PROJECT
BICESTER MOTION

TITLE
DRAINAGE LAYOUT SHEET 5

HYDROCK PROJECT NO. C-27280	SCALE @ A1 1:250
STATUS DESCRIPTION SUITABLE FOR STAGE 3	STATUS S2
DRAWING NO. (PROJECT CODE ORIGINATOR ZONE-LEVEL-TYPE-ROLE-NUMBER) 27280-HYD-00-ZZ-DR-C-7015	REVISION PO1

TITLE
DRAINAGE LAYOUT SHEET 6

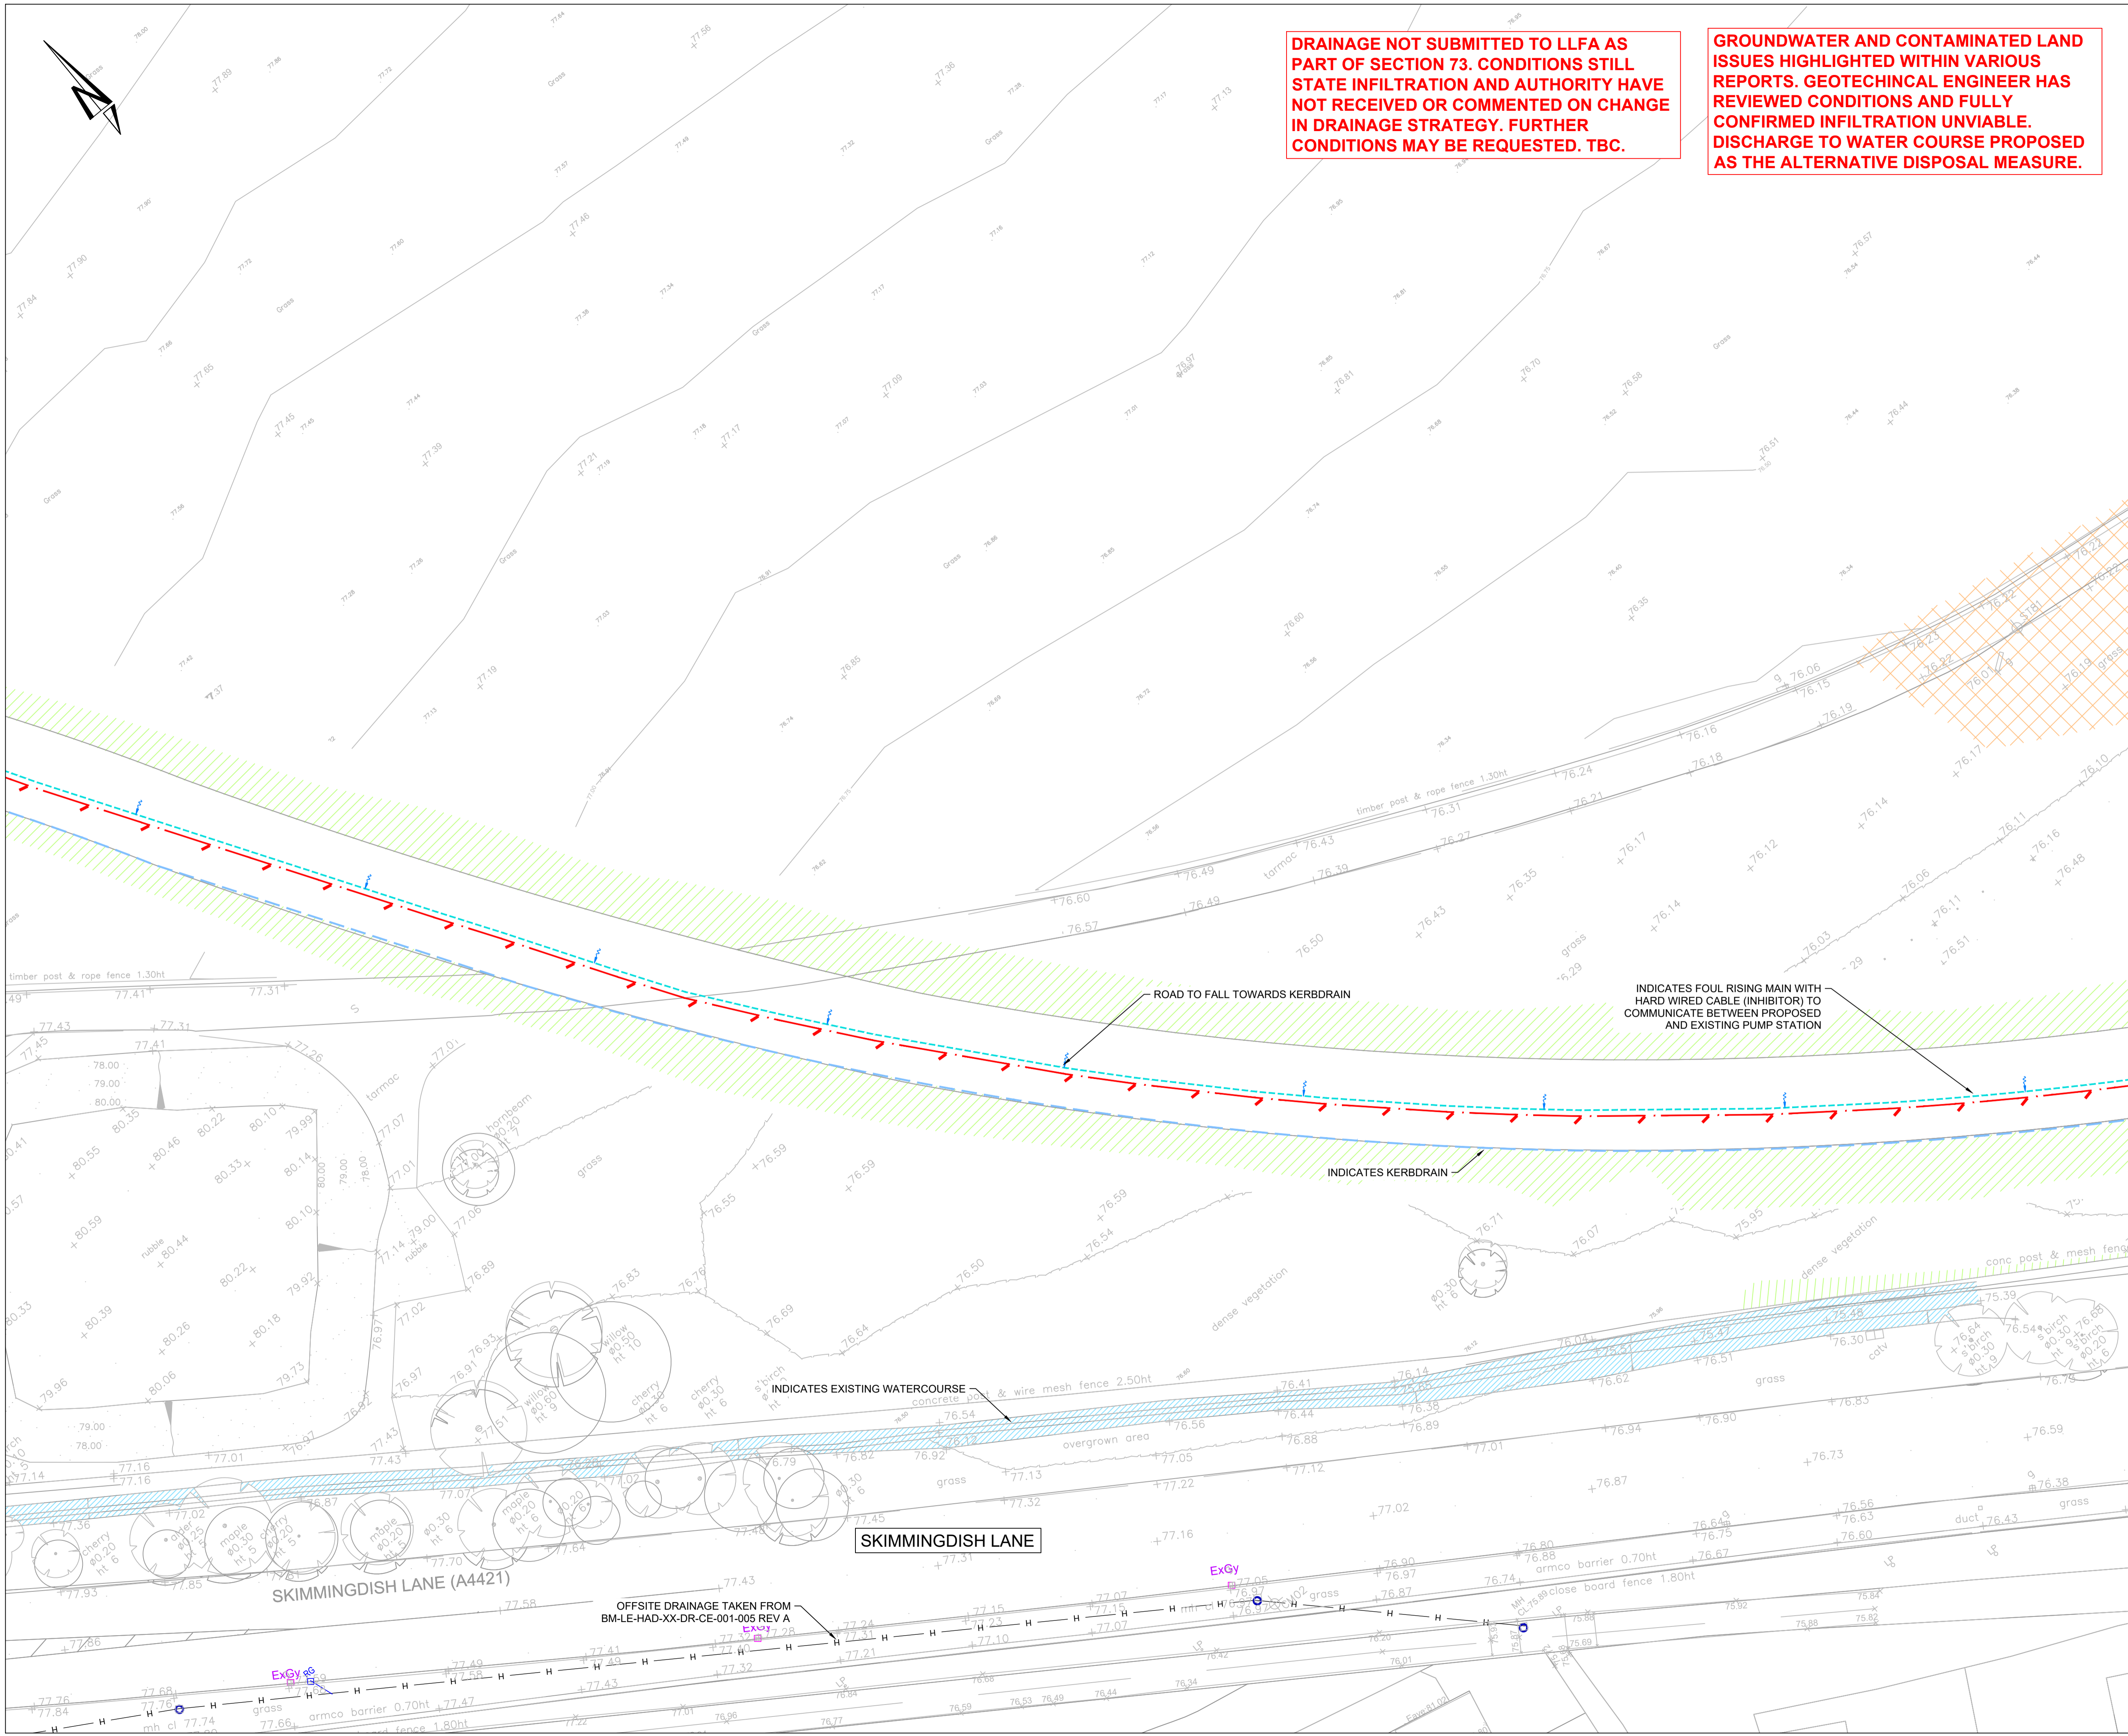
DRAINAGE NOT SUBMITTED TO LLFA AS PART OF SECTION 73. CONDITIONS STILL STATE INFILTRATION AND AUTHORITY HAVE NOT RECEIVED OR COMMENTED ON CHANGE IN DRAINAGE STRATEGY. FURTHER CONDITIONS MAY BE REQUESTED. TBC.

GROUNDWATER AND CONTAMINATED LAND ISSUES HIGHLIGHTED WITHIN VARIOUS REPORTS. GEOTECHNICAL ENGINEER HAS REVIEWED CONDITIONS AND FULLY CONFIRMED INFILTRATION UNVIABLE. DISCHARGE TO WATER COURSE PROPOSED AS THE ALTERNATIVE DISPOSAL MEASURE.

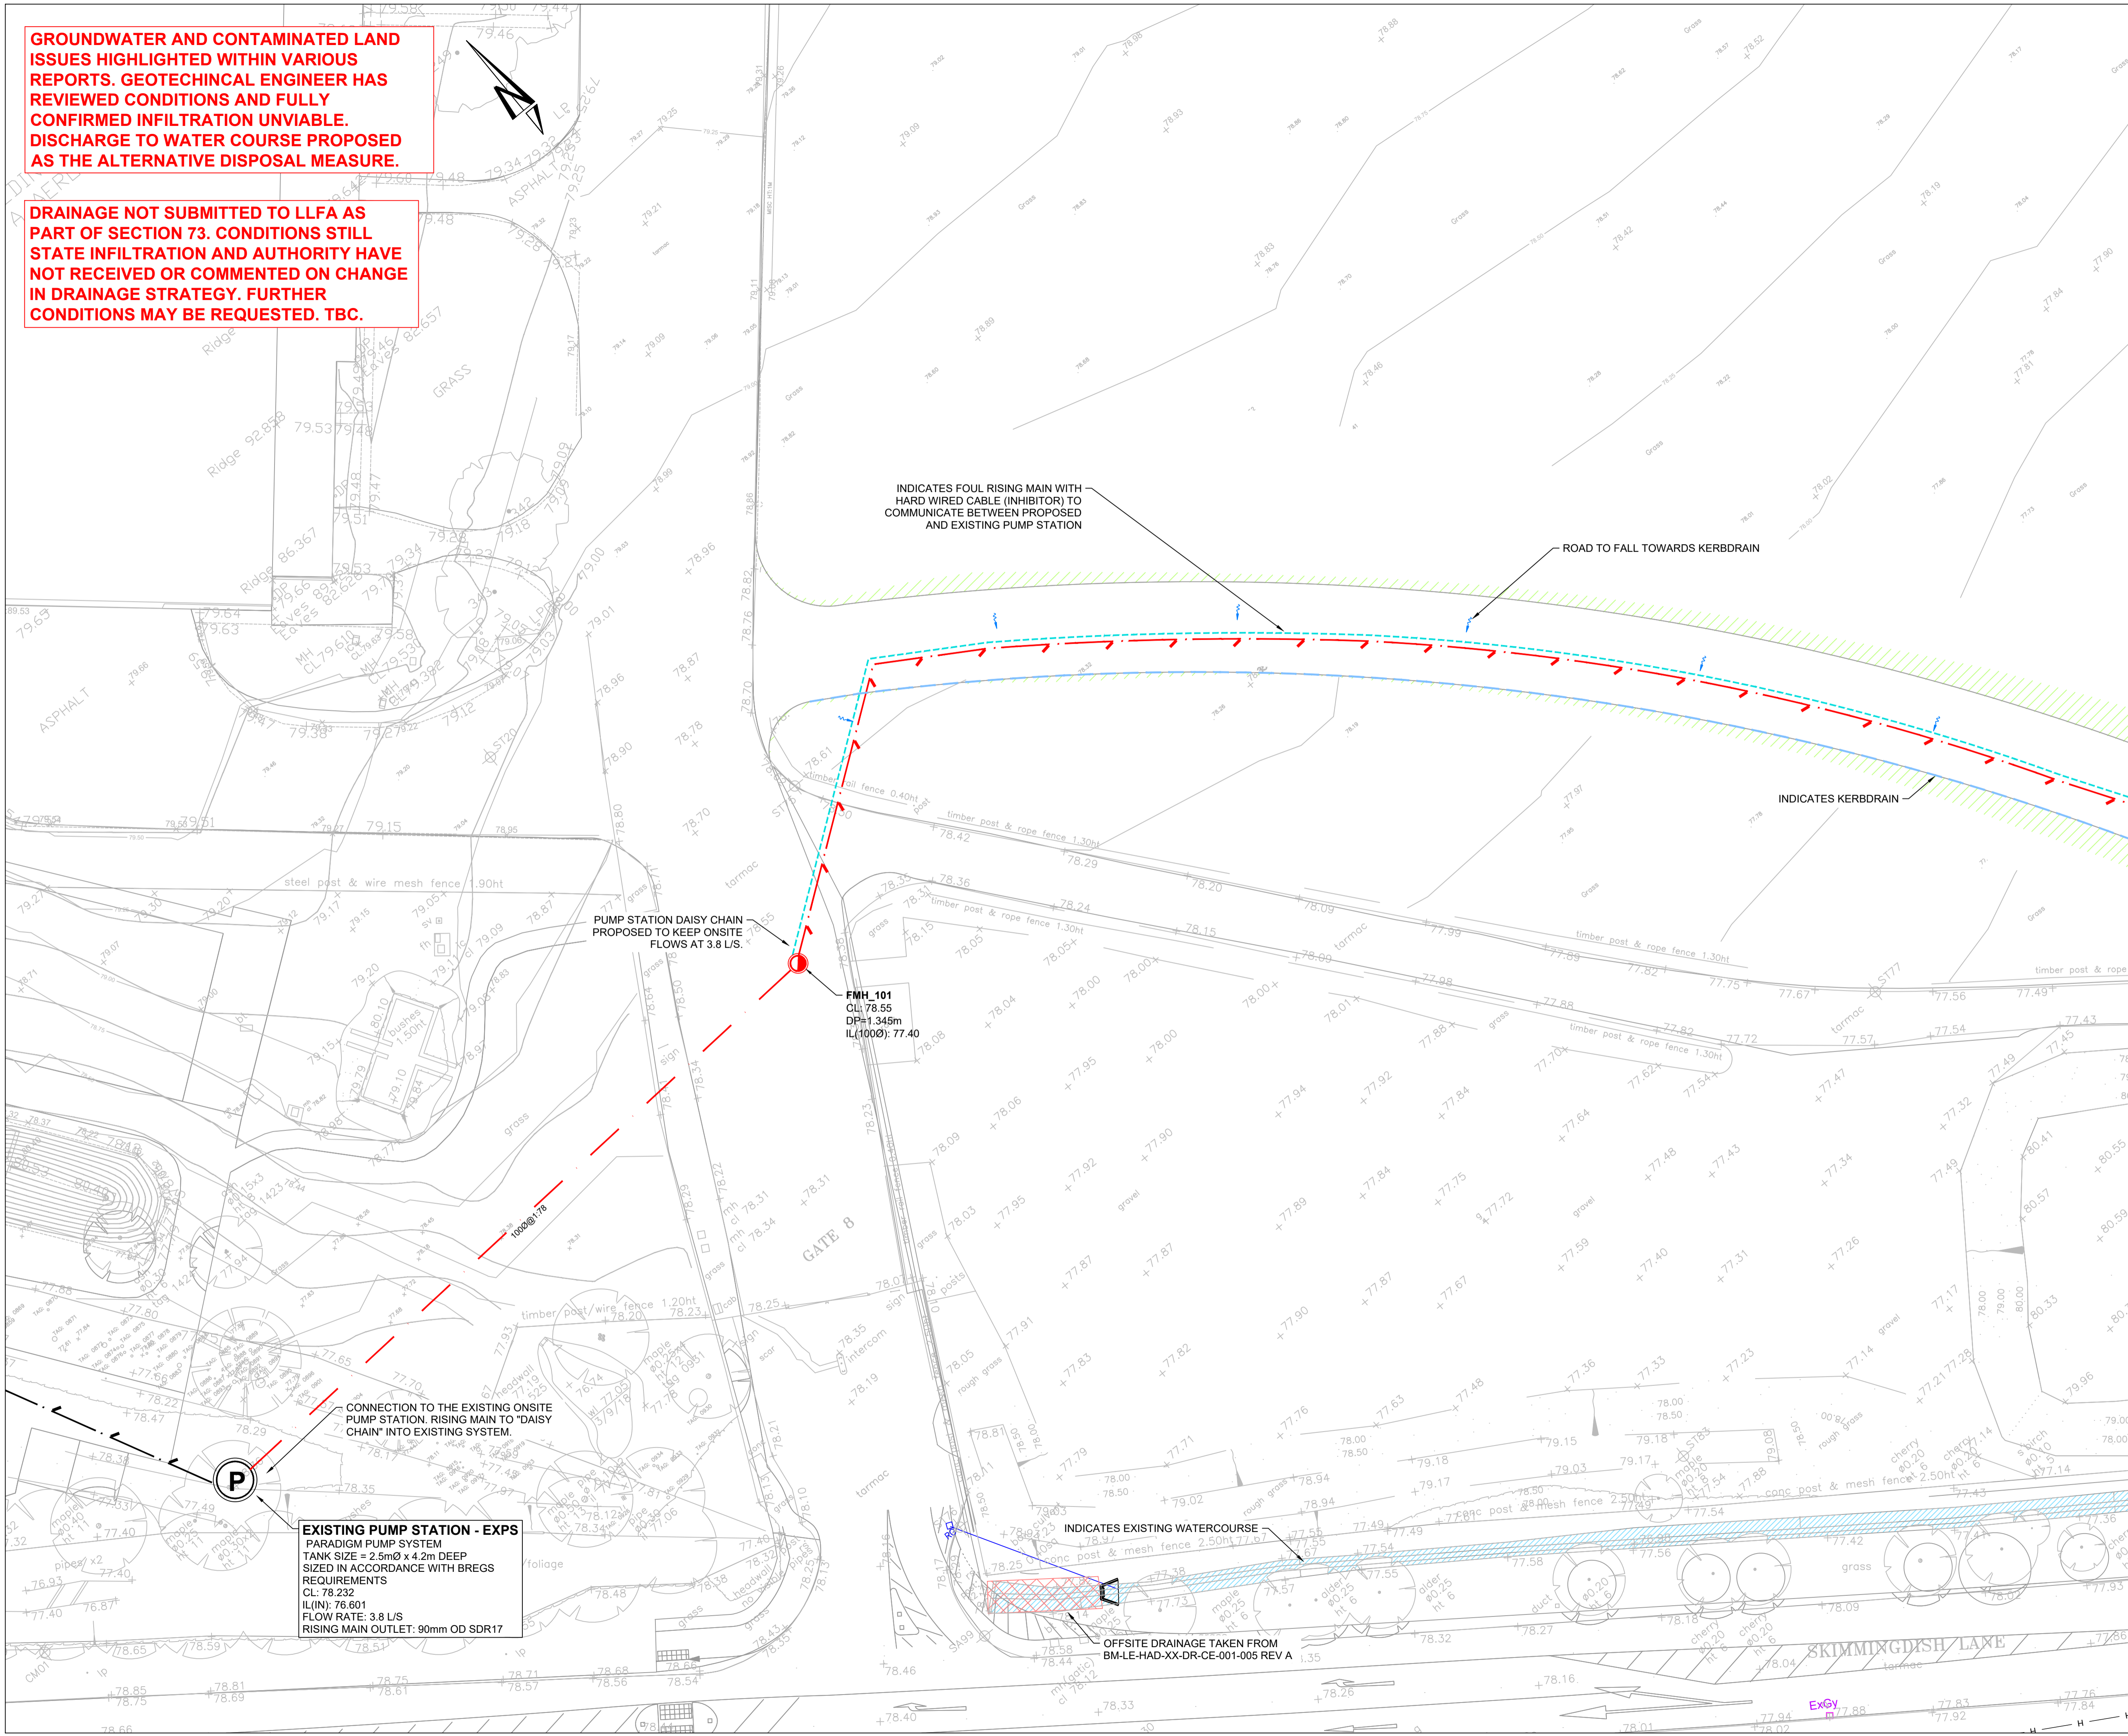
GROUNDWATER AND CONTAMINATED LAND ISSUES HIGHLIGHTED WITHIN VARIOUS REPORTS. GEOTECHNICAL ENGINEER HAS REVIEWED CONDITIONS AND FULLY CONFIRMED INFILTRATION UNVAILABLE. DISCHARGE TO WATER COURSE PROPOSED AS THE ALTERNATIVE DISPOSAL MEASURE.

DRAINAGE NOT SUBMITTED TO LLFA AS PART OF SECTION 73. CONDITIONS STILL STATE INFILTRATION AND AUTHORITY HAVE NOT RECEIVED OR COMMENTED ON CHANGE IN DRAINAGE STRATEGY. FURTHER CONDITIONS MAY BE REQUESTED. TBC.
